Project: 33616-SFTX HCA Lee's Summit
210 SE Blue Pkwy
Lee's Summit, Missouri 64063

RFI #8: Continuous Deck over Girders

6 TYPICAL CLOSURE DETAIL

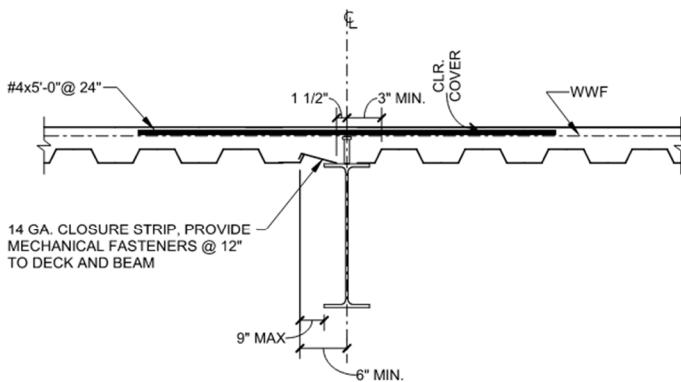
1. Please confirm that we can run decking continuous across the girders without opening them up as shown below. If we must follow the detail below, the field will need to rip the deck at all girders.

The deck is required to have its low flute centered on the girder to avoid following the referenced detail.
